INSPECTION REPORT

GAS TURBINE MAINTENANCE

MS 5001 Turbine Rotor Clearances

FSR NO. _____ TURBINE NO. 05620 (Dededo #1) DATE 2016.10.29

FIRST STAGE NOZZLE CLAMP

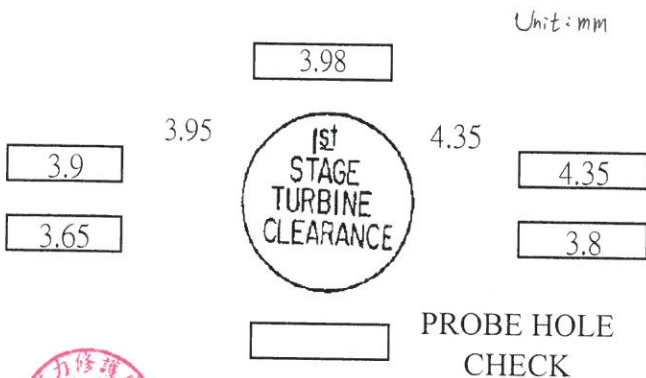
COMMENTS: *Measurement IN1 is somewhat high. We have to see upon the closing measurements of IR*

CLEARANCES FOR SHROUDED TIP BUCKETS

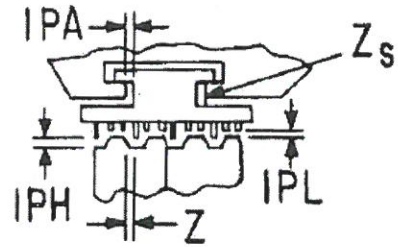
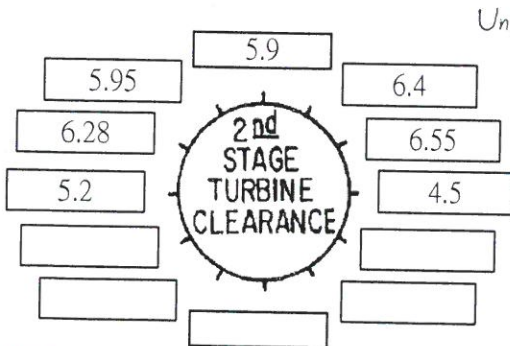
COMMENTS: 2N2, 2N3, 2F2 & 2R - not applicable for this blades / PL
 2F3, 2F4, 2A1 & 2A2 are out of tolerance, probably seals have some wear / PL
 XF - is out of tolerance - Probably the measurement was not right / PL

VIEW AT 1ST. STA NOZZLE CLAMP ARRANGEMENT

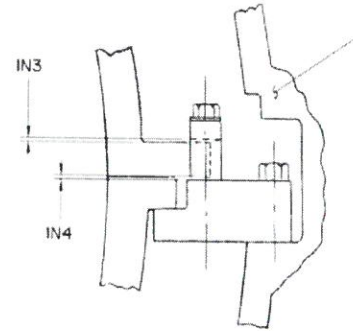
COMMENTS: *-IN1 is very high compared to spec. Looks like the nozzle is different that the one on the clearance diagram*

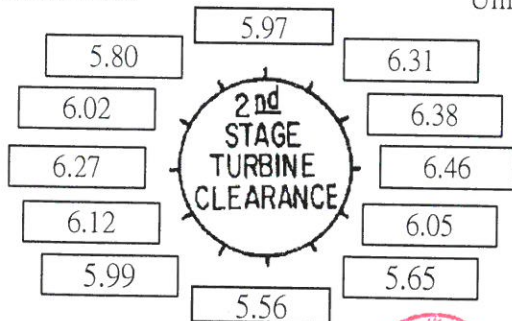
COMMENTS: *R is not applicable on this turbine*
- Zs + IPA are not applicable on this turbine. The nozzle is of a different kind.
 Witnessed + Approved
[Signature] 11/21/16
Juan Castellanos GE

ELLIPTICITY:

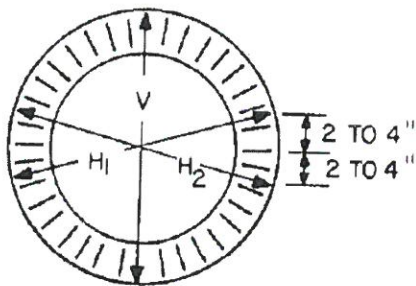
COMMENTS: - Visual inspection & NDT is reported on the NDT reports (separate)
- The ellipticity is 0.71 mm higher. No major concern on this.

RUN OUT

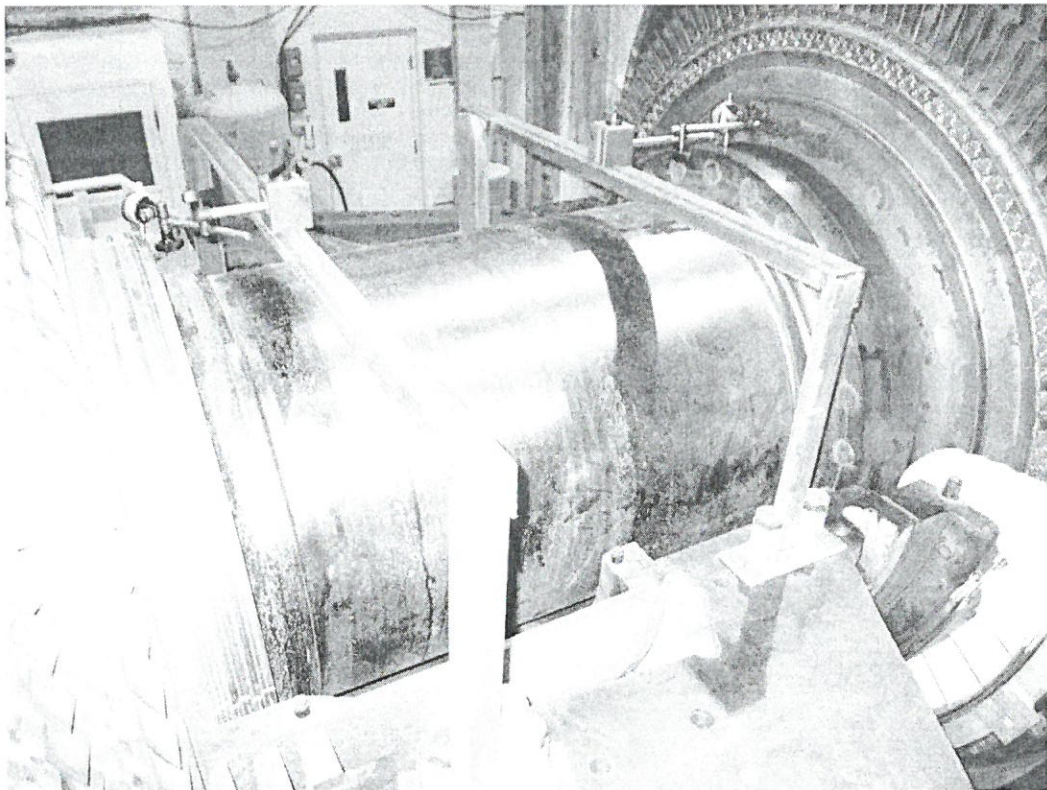
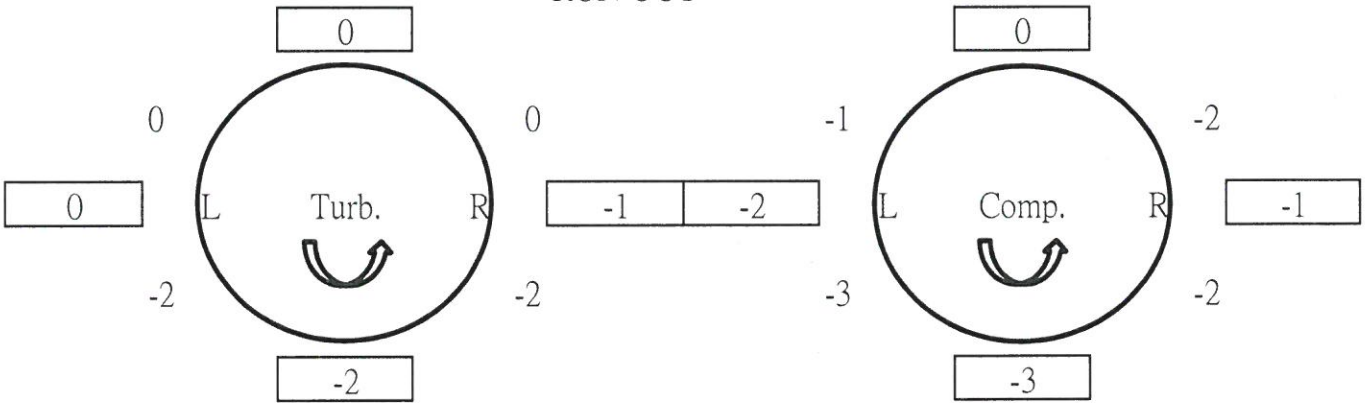
Run out is good. Witnessed & reviewed 11/1/2016
Juan Castellanos
 Juan Castellanos

(VIEW AT #2 BEARING STRAP)
No. 2 BEARING AREA

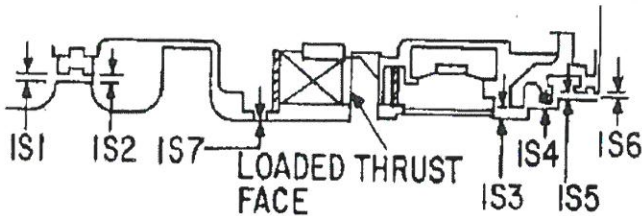
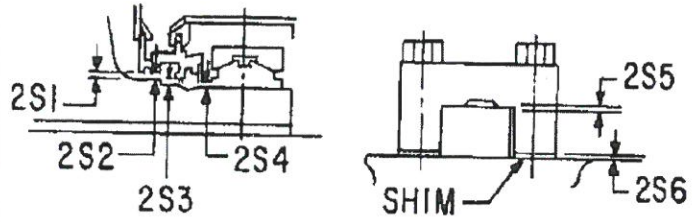
| | CLEARANCES | | VISUAL INSPECTION | | COMMENTS |
|-----|------------|-------|-------------------|-------------|-------------------------------|
| IS2 | 0.37 | 0.38 | OK, W | N | clearance is a little open |
| IS7 | 0.35 | 0.25 | OK, W | N | needs replacement next outage |

(VIEW AT #2 BEARING STRAP)
No. 2 BEARING AREA

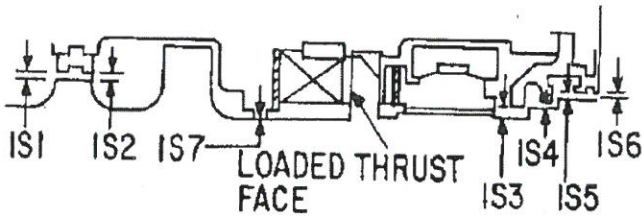
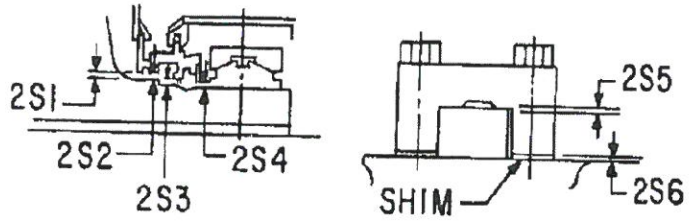
| | CLEARANCES | | VISUAL INSPECTION | | COMMENTS |
|-----|------------|-------|-------------------|-------------|---|
| 1S1 | 0.35 | 0.40 | high clearance | N | Final. Replace on next outage. <i>JPC</i> |
| 1S2 | 0.37 | 0.37 | high clearance | N | Final. Replace on next outage. <i>JPC</i> |
| 1S7 | 0.25 | 0.20 | high clearance | N | Final. Replace on next outage. <i>JPC</i> |

Accessory Gear

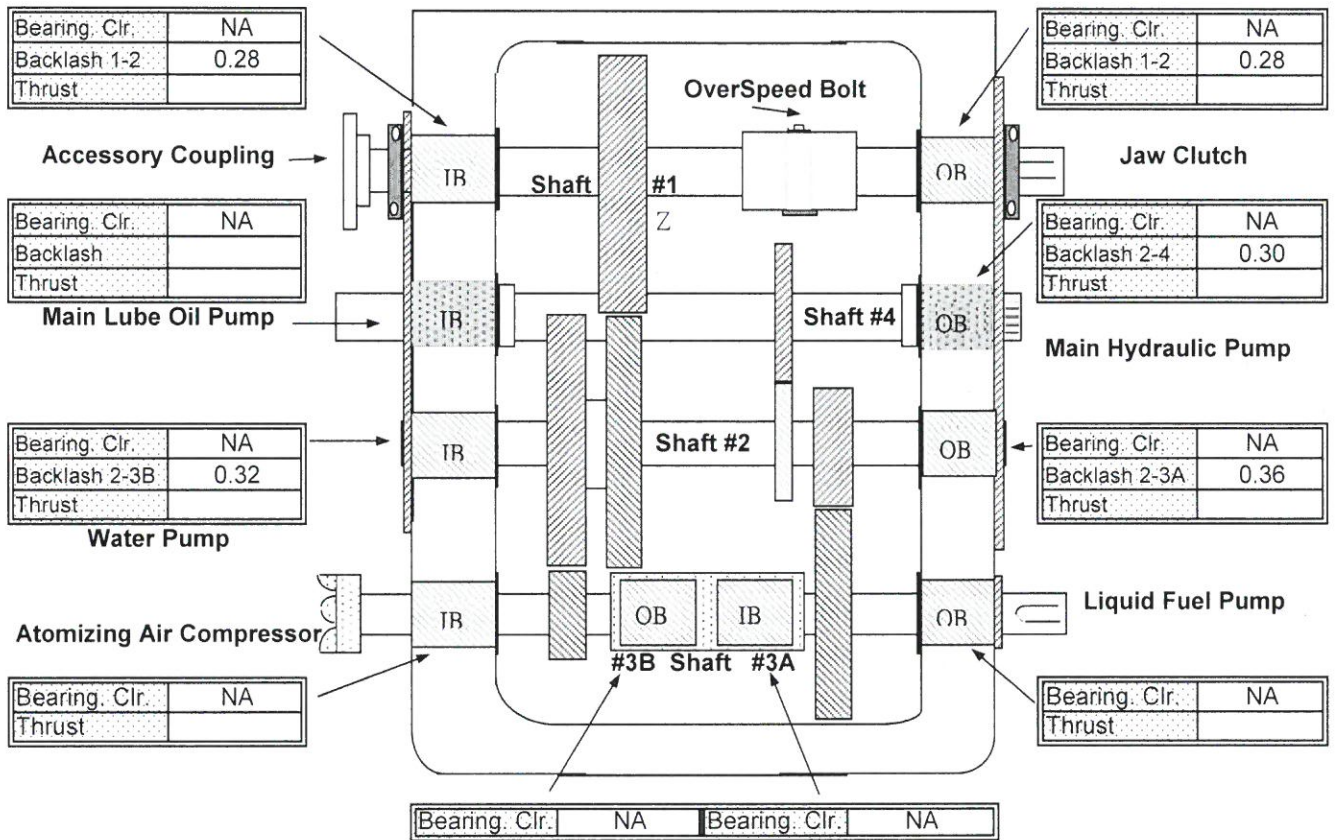
Comments:
 - Backlash is good. Spec is 0.13 to 0.40 mm
 - Thrust or brg. clearance could not be obtained

Coupling Alignment

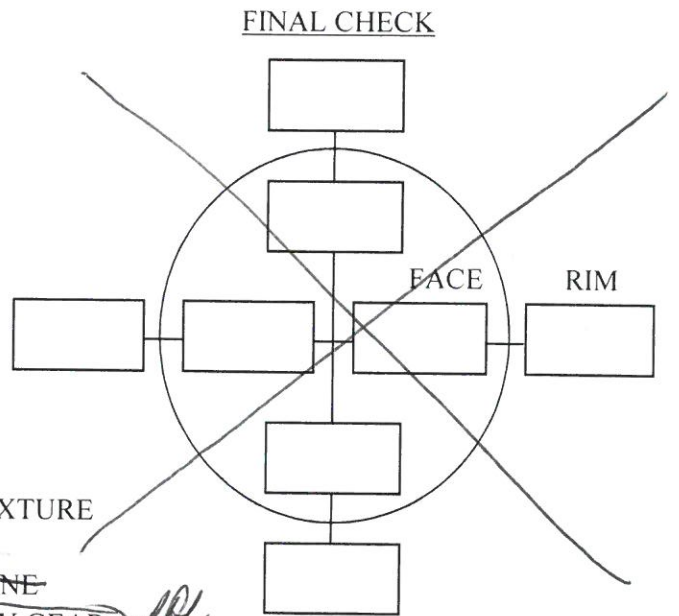
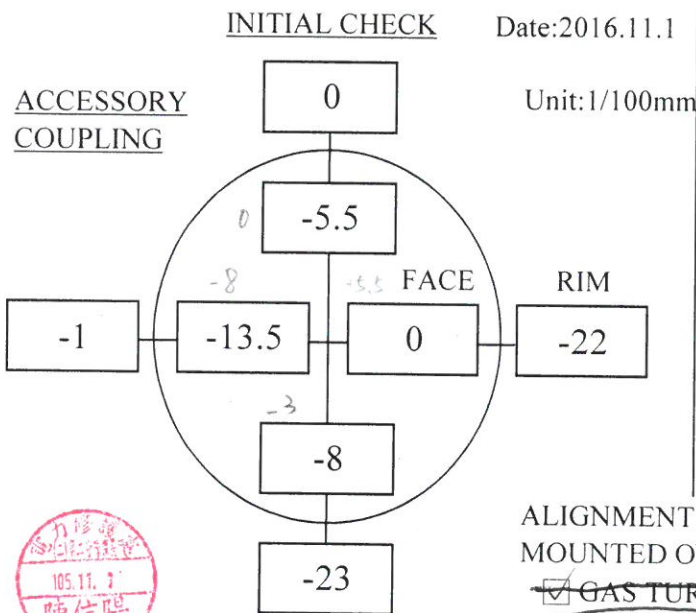
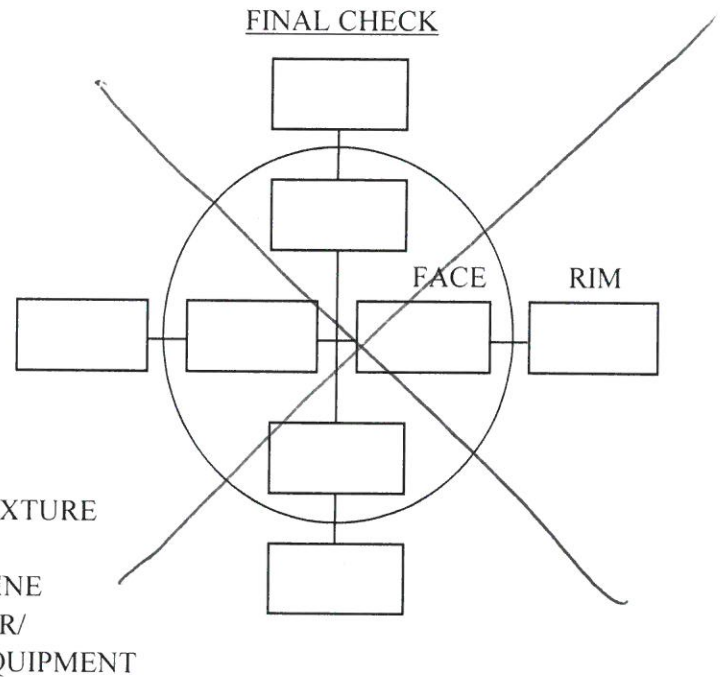
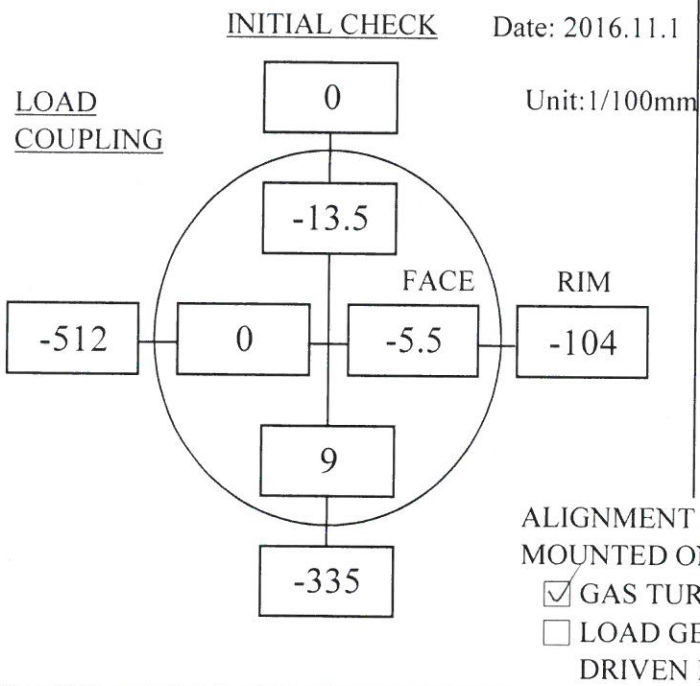
COMMENTS: Alignment is a little off on both load & accs. dpl
